**Appendix F**  
**Utility Plans and Correspondence**

## HWY 50 REGION OF PEEL --- UTILITY CONTACT LIST

**From:** Agnew, Tim  
**Sent:** Wednesday, September 07, 2011 2:02 PM  
**To:** 'nathalie.baudais@hdrinc.com'  
**Cc:** Chiu, Edward; Servera, Vinor  
**Subject:** Project #4956 - Highway 50 Road Widening

Dwg # - 6

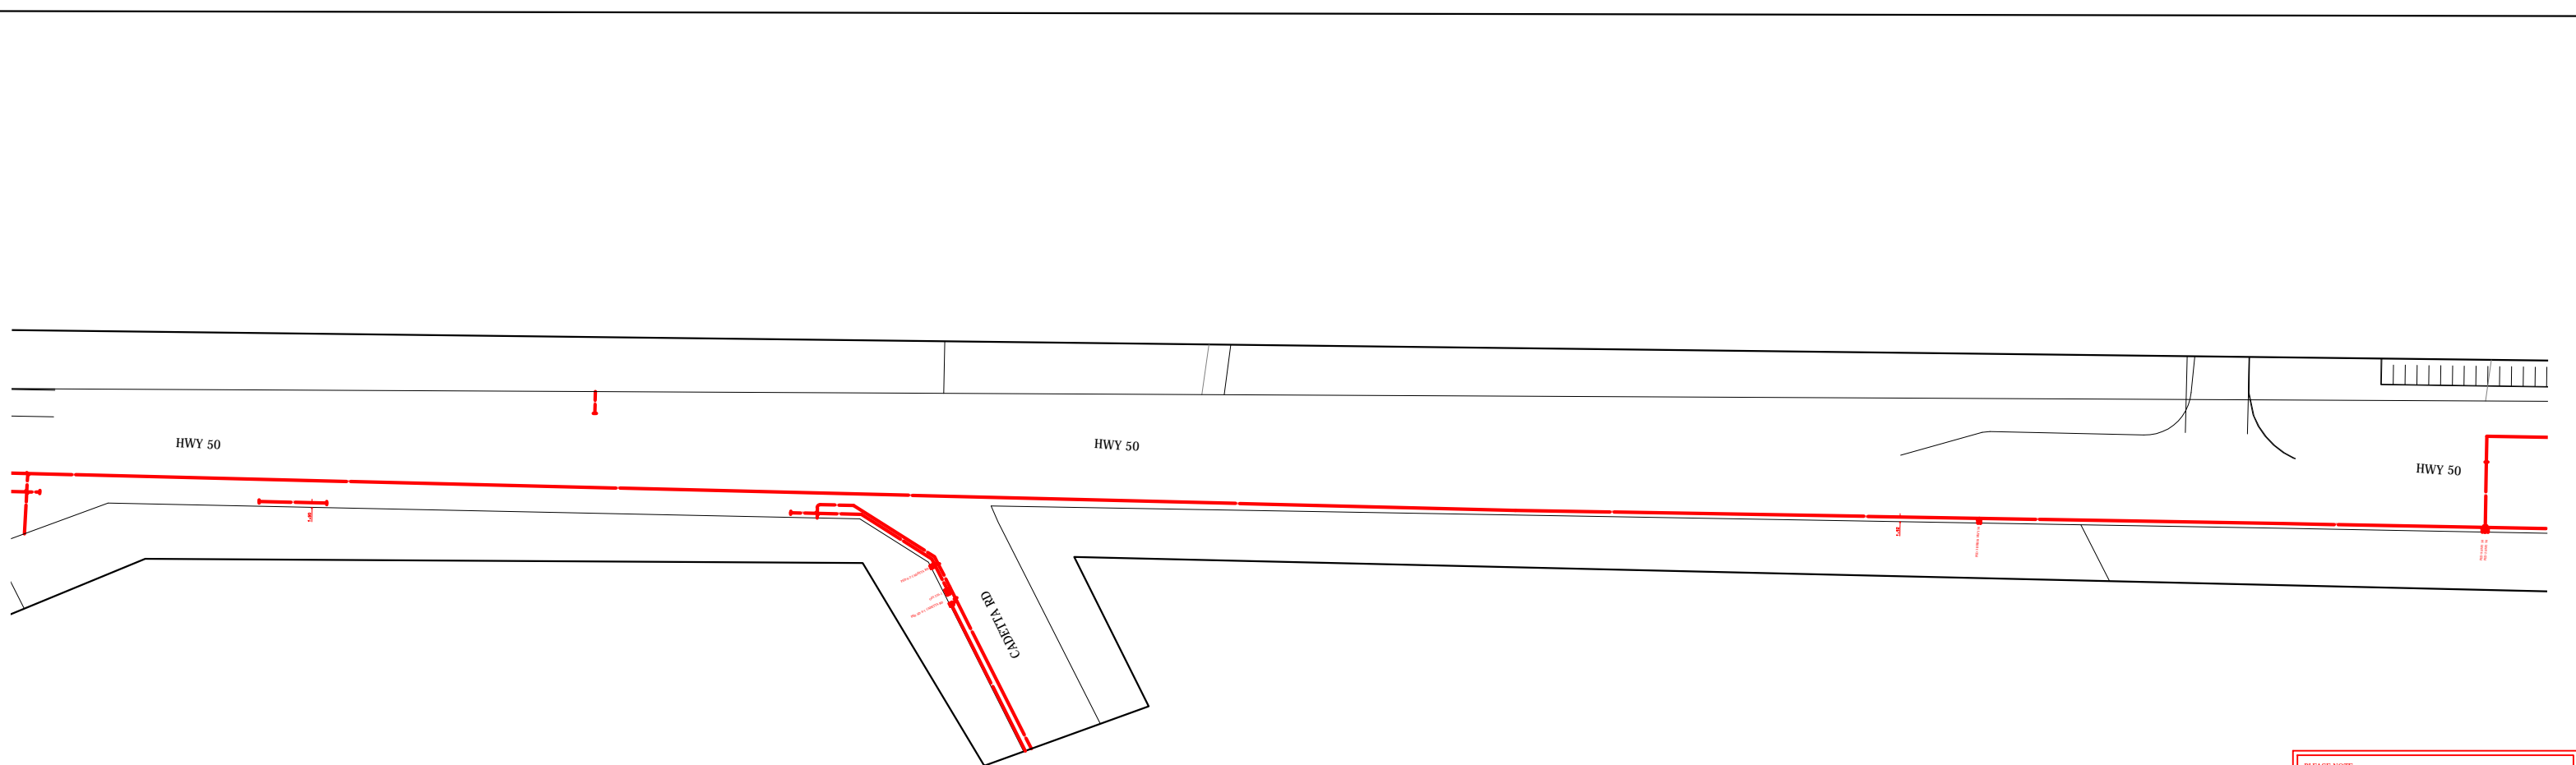
HAND DIG  
 if within 1m of Bell plant

HAND DIG  
 when crossing Bell plant

Maintain clearance of 0.6m

Dwg # - 7

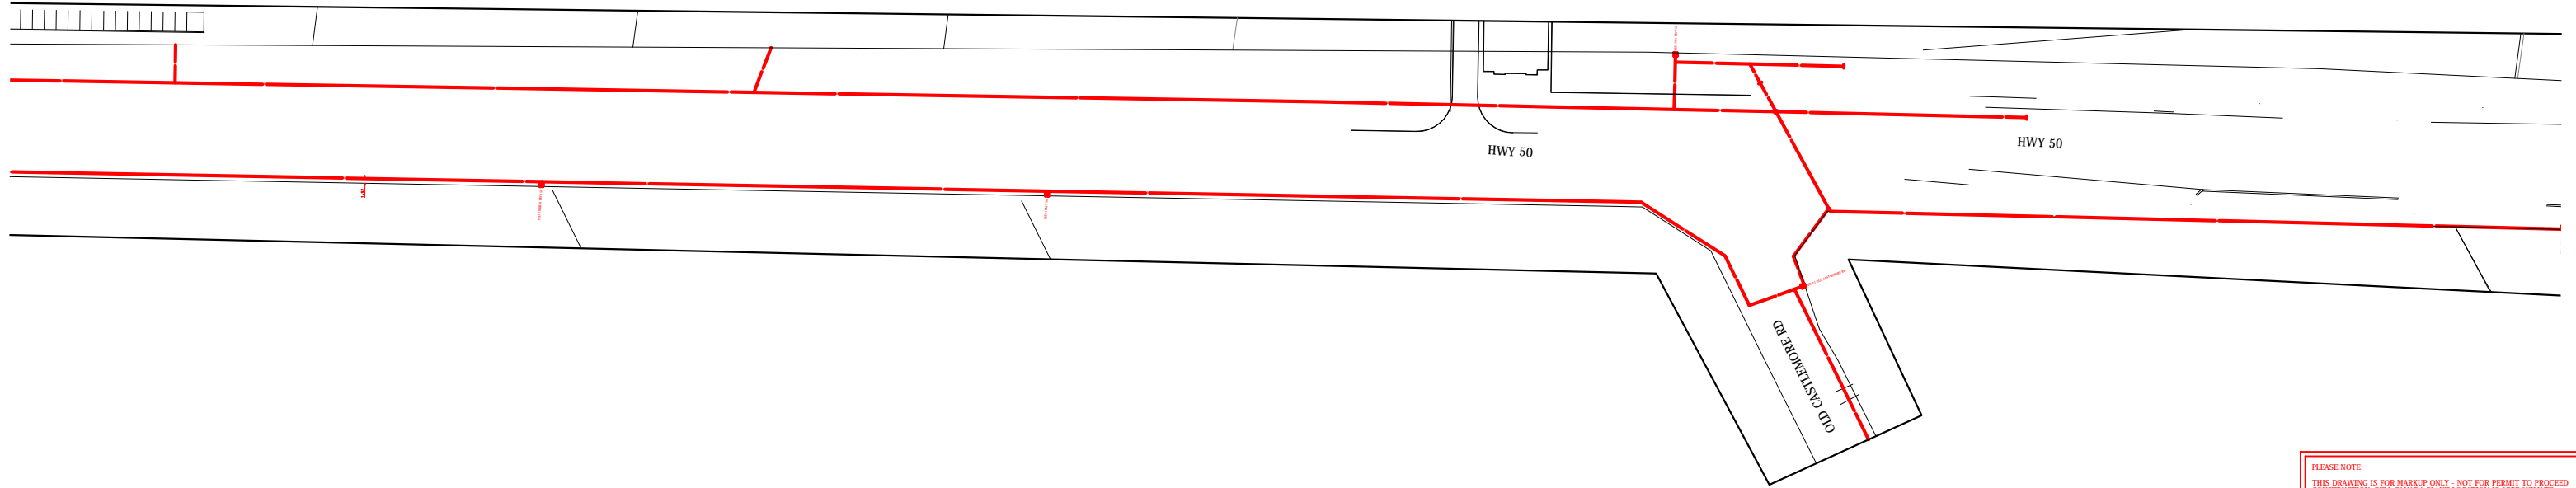
HAND DIG  
 if within 1m of Bell plant

HAND DIG  
 when crossing Bell plant

Maintain clearance of 0.6m

Dwg # - 8

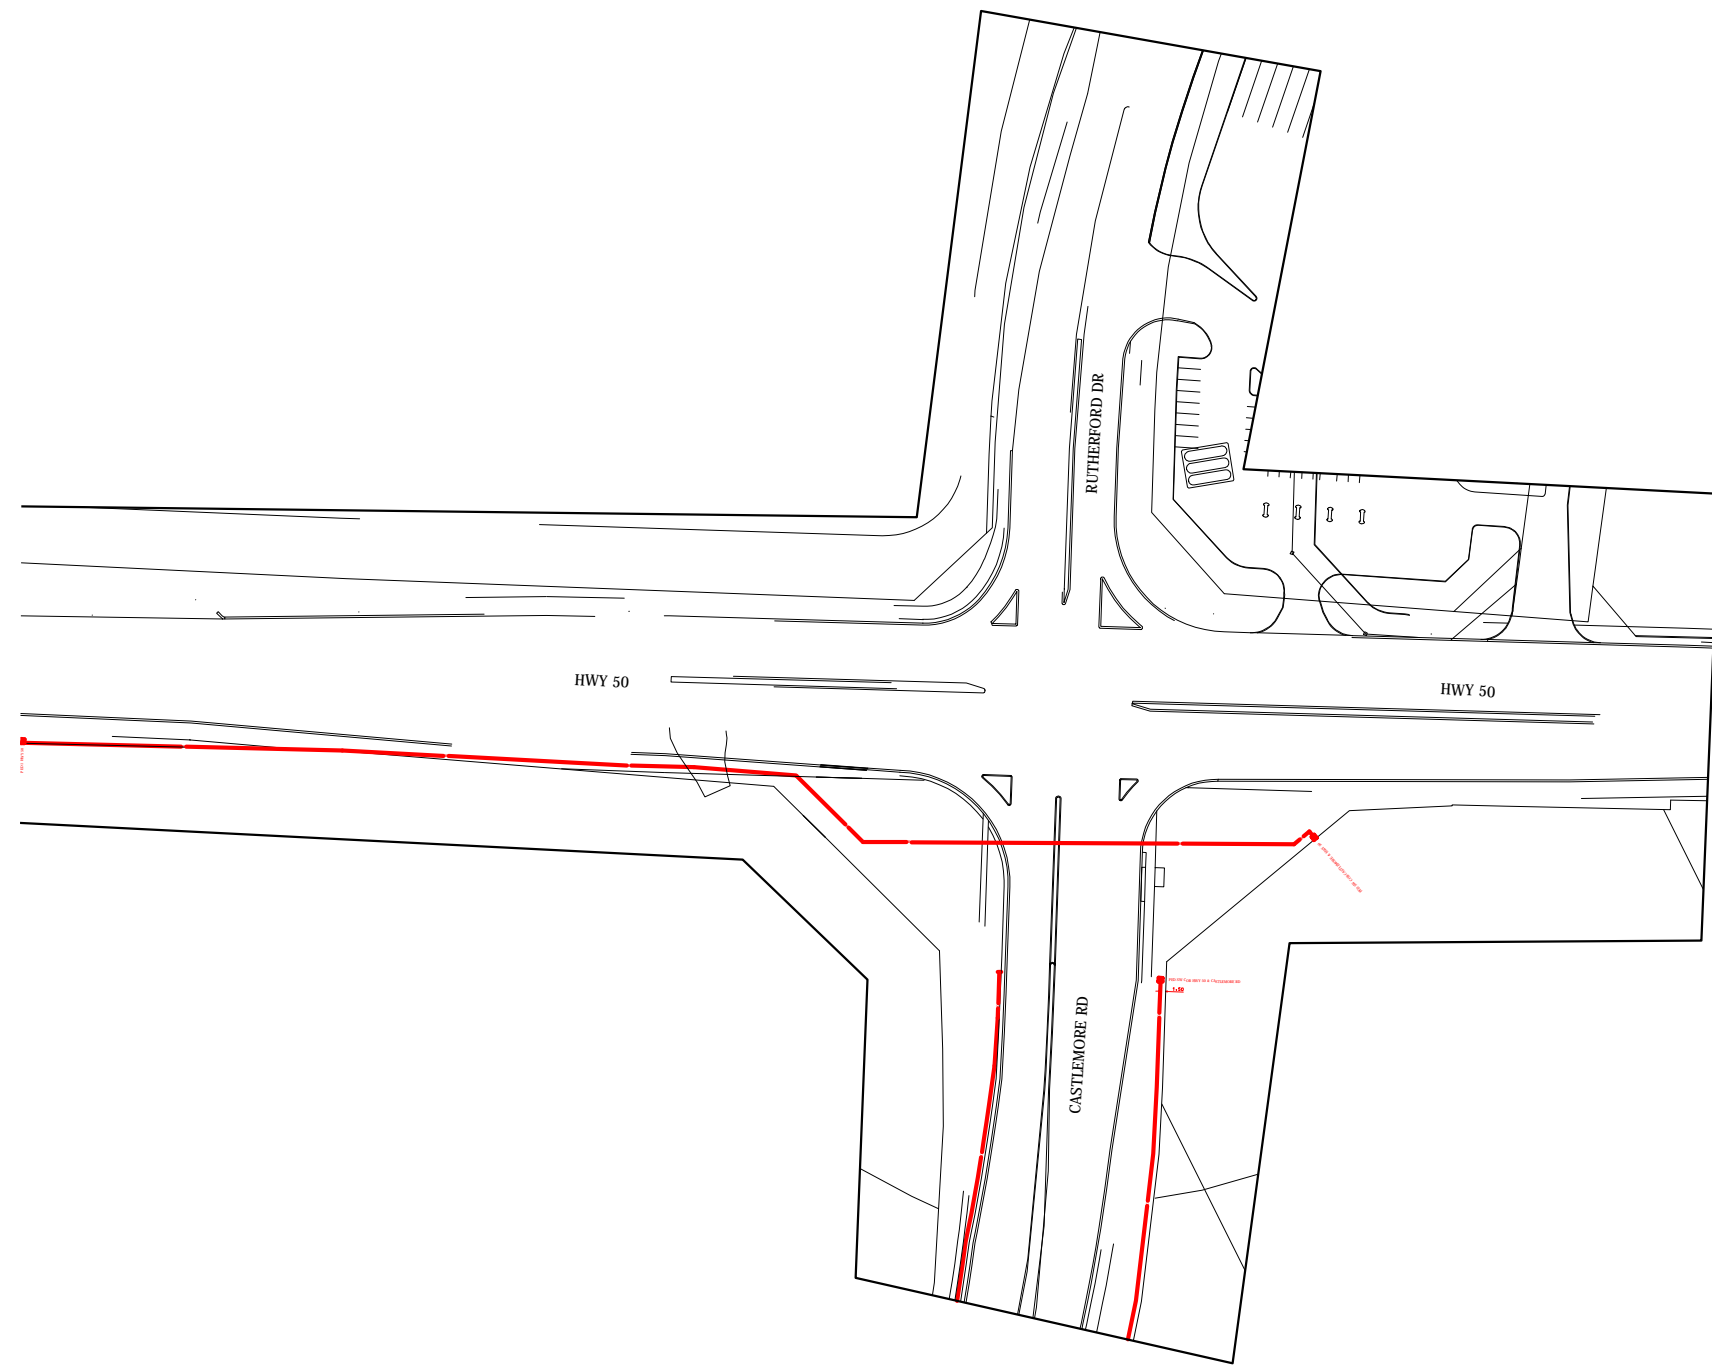
HAND DIG  
 if within 1m of Bell plant

HAND DIG  
 when crossing Bell plant

Maintain clearance of 0.6m
